STAFF RECOMMENDATION

202 Elmington Place

January 20, 2021

Application: New Construction—Addition and Outbuilding

Figure 3: Site plan. The front is to the right.

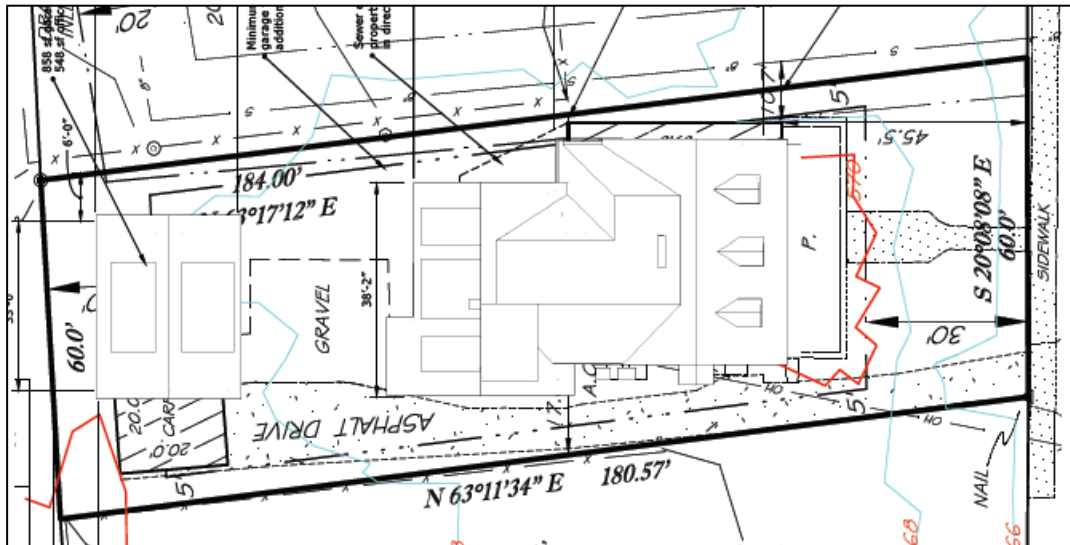
Height & Scale: The addition will have a side-gabled primary component matching the ridge and eave height of the original roof, with a flat-roofed hyphen connecting the two gabled forms. The right side of the addition will be stepped in eight feet (8') from the side of the house, and after a one foot (1') by three foot (3') alcove the left side will extend six feet (6') beyond the left side of the historic house.

Additions should generally be kept to the rear of an historic house, however Staff finds the additional width to be appropriate because the axis of the property lines are not parallel with the orientation of the house and the addition is stepped in to maintain the minimum setback on the right side.

Staff finds the height and width of the proposed addition to be subordinate and to meet Sections II.B.1.a. and II.B.1.b. of the design guidelines.

Roof Plan

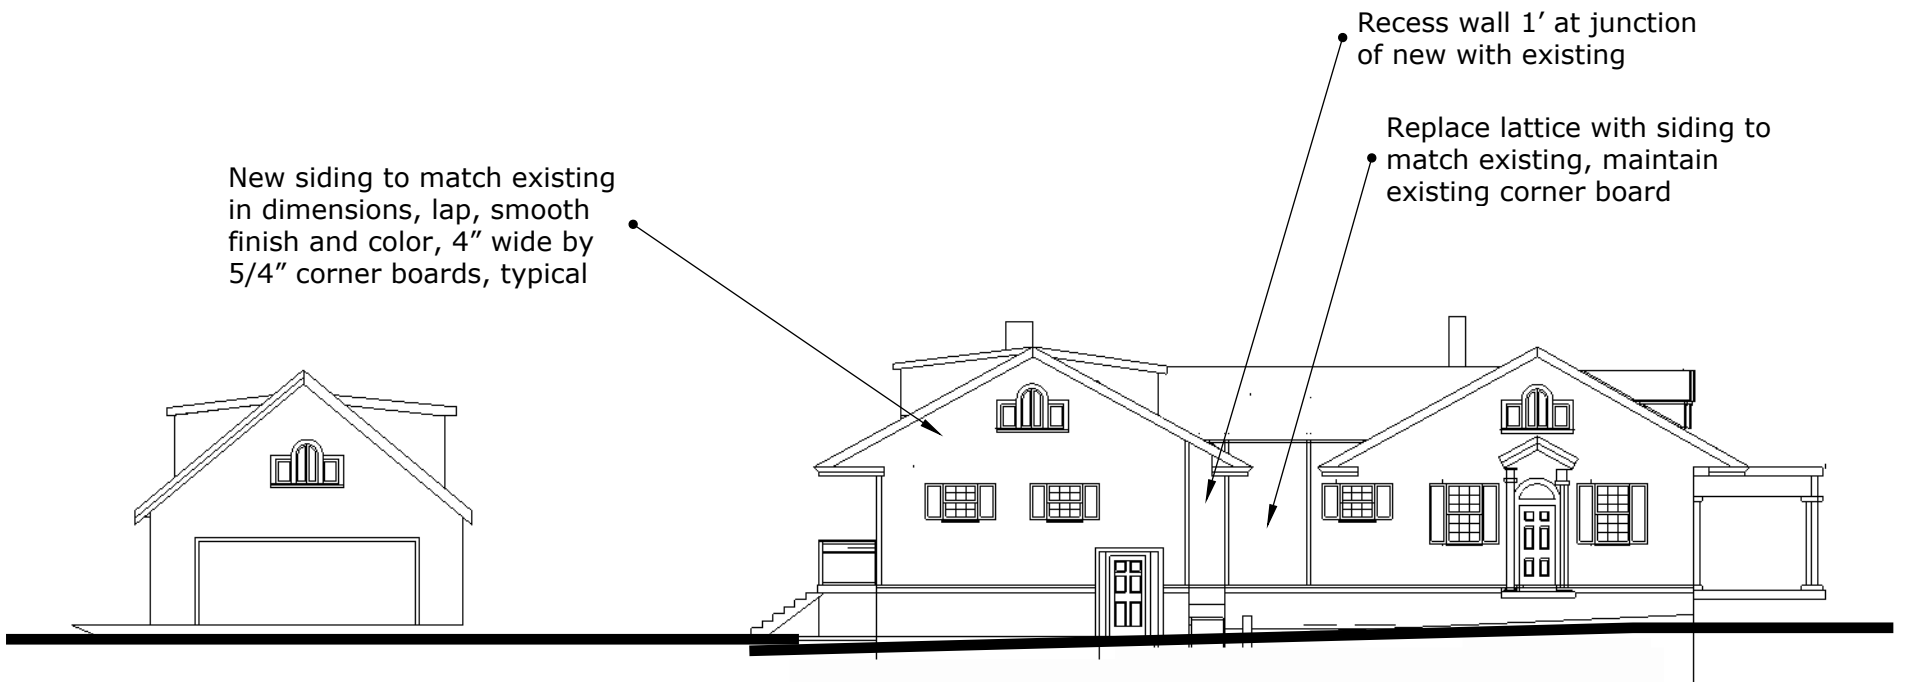
Roof form: The addition will have a side-gabled roof, matching the form, pitch, and orientation of the historic house’s roof. The new roof will have a front-facing dormer, which is appropriate because the historic house has front-facing dormers. The new and existing side-gabled roofs will be attached by extending an existing flat-roofed component toward the rear.

In the proposal, the addition ties in flush with the left side hip-ridge on the historic house. Additions to hip-roofed houses have previously been required to step in from the side slopes in order to differentiate the new construction from the historic, and to leave the historic hip-ridges intact.

With a condition that the roof of the addition is stepped in from the hip-ridge on the left side of the historic house, Staff finds that the roofs of the addition are compatible with the historic house and meet S section II.B.1.e. of the Design Guidelines.

1. The roof of the addition is stepped down six inches (6") from the hip-ridge on the left side of the historic house; and
2. The foundation material, deck and railing materials, and window and door selections are approved prior to purchase and construction.

Rear and
 Garage
 Elevations

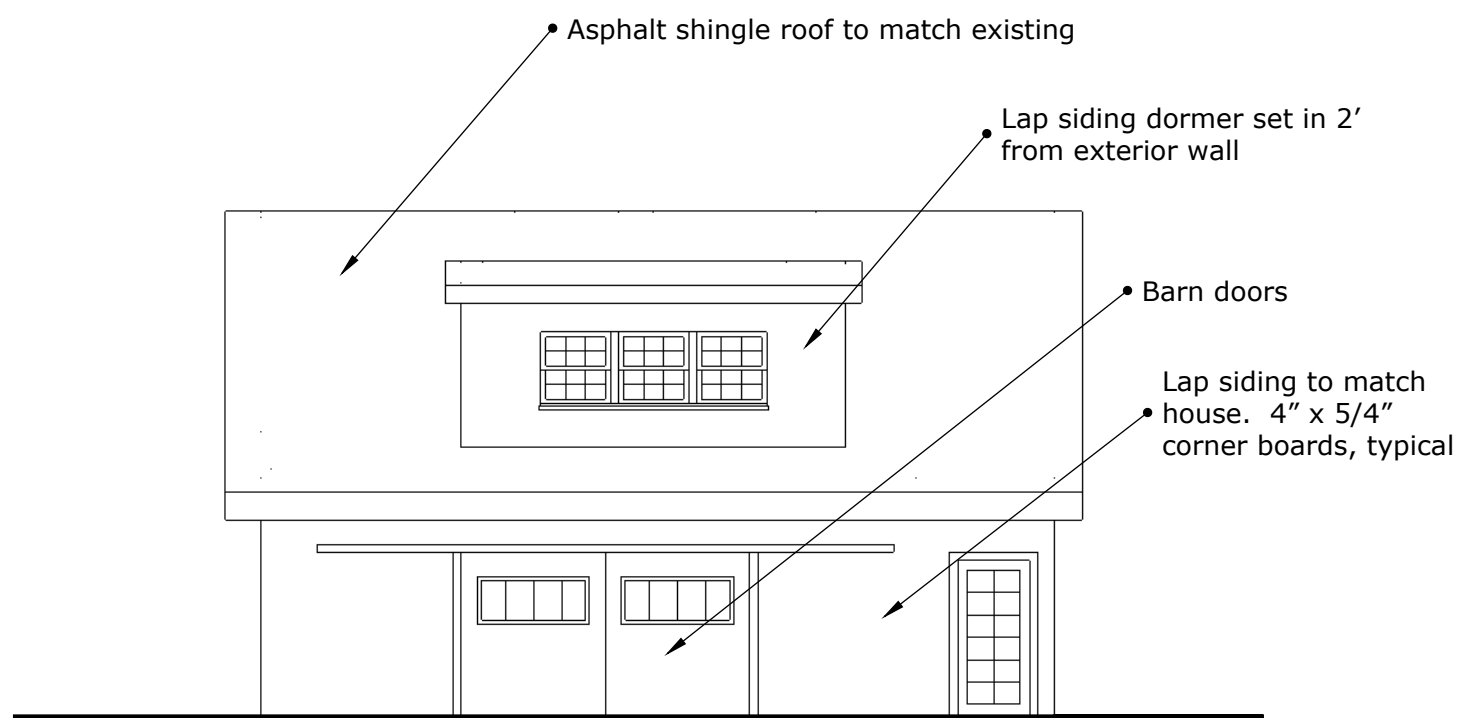
Outbuilding: The proposal also includes a one and one-half-story detached outbuilding at the rear of the lot. The outbuilding is not proposed to include a detached accessory dwelling unit.

Potential 1-Story or 1.5-Story Outbuilding	Proposed Outbuilding
Ridge Height	24'	21'
Eave Height	10'	8'-6"

The proposed outbuilding will have a gabled roof with a pitch matching that of the house, with low-sloped shed-roofed dormers.

With a condition that the foundation material and the window and door selections are approved prior to purchase and installation, Staff finds that the project meets Section II.B.1.h. of the Design Guidelines for new construction-materials on outbuildings.
